Final Remediation Works for the Former Cresco Site, Bayswater

CSBP Limited

**Report and recommendations
of the Environmental Protection Authority**

**Environmental Protection Authority
Perth, Western Australia
Bulletin 1175
June 2005**

Figure 3.1.3 Classification of ecosystem type for each of the broad categories of indicators (in grey boxes at left of the diagram)

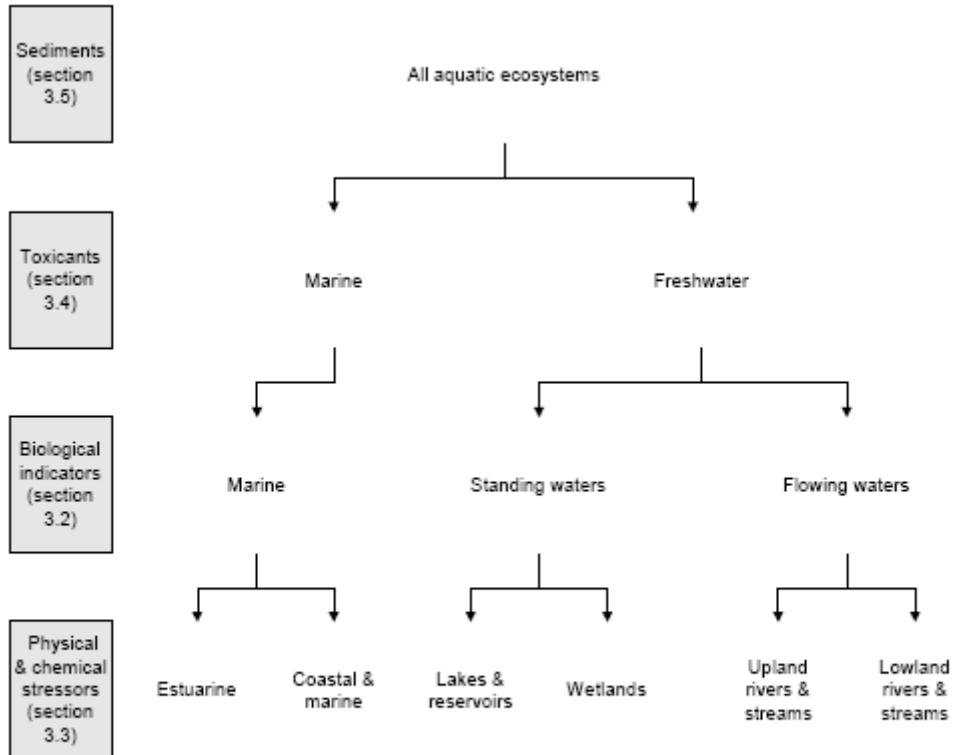
Thirdly, could the proponent comment on the use of freshwater ecosystem trigger levels for an urban drainage system (Bayswater Main Drain) that discharges to the Swan River.

Under the *Australian and New Zealand Guidelines for Fresh and Marine Water Quality* (ANZECC/ARMCANZ, 2000), an ecosystem classification decision tree (Figure 3.1.3, see below) is applied such that toxicants are split into one of two aquatic ecosystem types - marine and/or freshwater ecosystems. Importantly, the decision tree does not differentiate estuarine ecosystems, but rather sees these 'lumped' with marine ecosystems.

In terms of physical and chemical stressors (including total nitrogen and total phosphorus), the *Australian and New Zealand Guidelines for Fresh and Marine Water Quality* (ANZECC/ARMCANZ, 2000) differs from that for toxicants in as much as trigger values specific to estuarine systems may also be applied. CSBP concurs with the Swan River Trust's view that for physical and chemical stressors, estuarine trigger values should be applied (in accordance with the decision tree, see below).
